KNX Multitouch PRO firmware update urgency (System M, System D)

MTN6215-0310 and MTN6215-5910

Picture 1: configuration leading to the issue

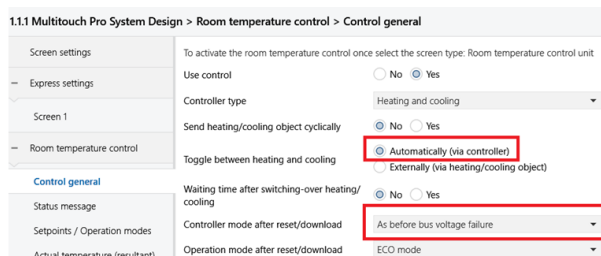
Topic: Under some circumstances it can happen that EEPROM memory can be damaged.

Conditions:

- Room temperature control Enabled
- Automatically (via controller)
- Controller mode after reset/download
- As before bus voltage failure
- Heating and cooling toggled automatically
- Controller mode after reset/download is set a before voltage failure

Result: Based on this configuration, under the above conditions (and only in this case), the EEPROM memory will be written cyclically and may cause the memory to be damaged.

To solve update firmware to version 29.3.
